DELEGATED PLANNING APPLICATION REPORT

App Ref: 230842/FUL

Address: Thames Quarter, 2 Napier Road, Reading, RG1 8FS

Proposals: External wall mounted air conditioning condensers and air intake and extract louvres

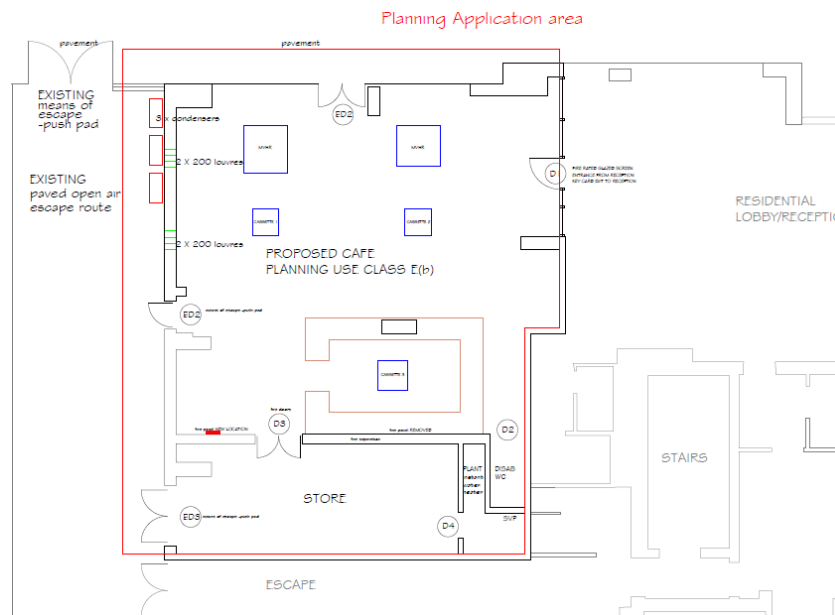
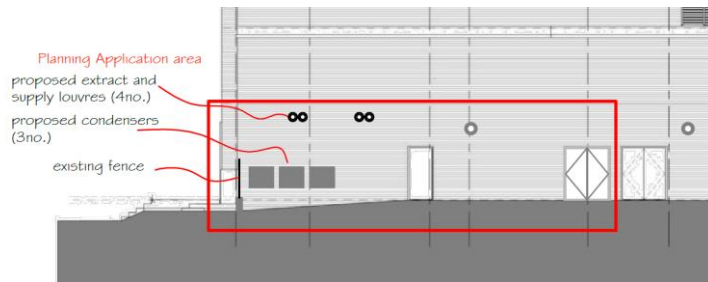
There would be three units installed externally with the nearest habitable apartment window 9.8 metres above the a/c units.

The equipment would be sited on the side wall with condensers screened with an existing boundary fence. The proposed condensers are Midea X3 Outdoor units - MOD30U-36HFN8-Q(GA)

The proposal includes for three wall mounted air conditioning condenser units and air intake and extract louvres on the side elevation facing the embankment of the railway line and adjacent to a private escape and service pavement area as part of the overall building. There is an existing boundary fence to the edge of public highway, which provides some additional screening. The units would be grey and white/cream powder coated metal.

The proposed units and louvres would be very modest in scale and sited to the side of the unit. It is considered that their scale and appearance would be wholly acceptable within the context of the large scale of the overall building and the surrounding appearance of the railway bridge. The proposal is, therefore, considered to accord with relevant policies CC7, and CR2.
